Access Compliance Report

Public Rights-of-Way

Intersection ID: 42474	Main Street: SIR_CHARLES_PL	Cross Street: WINDSOR_CASTLE_LN	Location:	N
ADA ID: E80F2FD64D74	Ramp Type: BlendTrans1	Initial Pass/Fail: Fail	Overall Compliance: No	Severity Score: 30

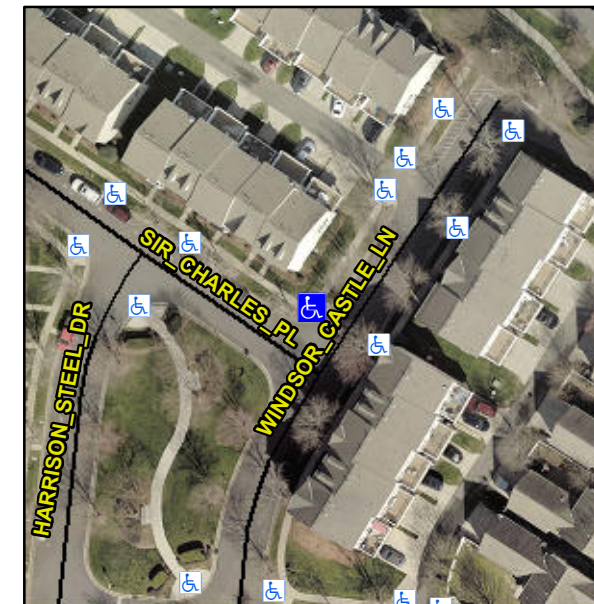
R304.5.1, R304.5.3

Compliance	Description	Data	Compliance	Description	Data
N/A	Ramp Length (in)	87.0	Yes	BlendTrans Slope (%)	4.0
No	Ramp Width (in)	33.0	No	BlendTrans XSlope (%)	6.3
N/A	Flare Type LT	N/A	N/A	Flare Type RT	N/A
N/A	Flare Slope LT (%)	N/A	N/A	Flare Slope RT (%)	N/A
N/A	Flare Traversable LT?	N/A	N/A	Flare Traversable RT?	N/A
N/A	Landing Length (in)	N/A	N/A	DWS Provided?	N/A
N/A	Landing Width (in)	N/A	N/A	DWS Contrast?	N/A
N/A	Landing Slope (%)	N/A	N/A	DWS Length (in)	N/A
N/A	Landing X Slope (%)	N/A	N/A	DWS Full Width?	N/A
N/A	Landing Curb? (Y/N)	N/A	N/A	DWS Offset (in)	N/A
N/A	Shared Landing?	N/A			
N/A	Gutter Ponding?	N/A	N/A	Gutter Slope (%)	N/A
N/A	Gutter Lip Ht (in)	N/A	N/A	Gutter X Slope (%)	N/A
N/A	Painted X Walk1?	No	N/A	Painted X Walk2?	No
	X Walk 1 Direction	To SW		X Walk 2 Direction	To SE
	X Walk 1 Width (in)	N/A		X Walk 2 Width (in)	N/A
	X Walk 1 Slope (%)	1.3		X Walk 2 Slope (%)	3.5
	X Walk 1 X Slope (%)	2.8		X Walk 2 X Slope (%)	3.6

Remove & Replace Curb Ramp With Two New Directional Ramps or Equivalent.
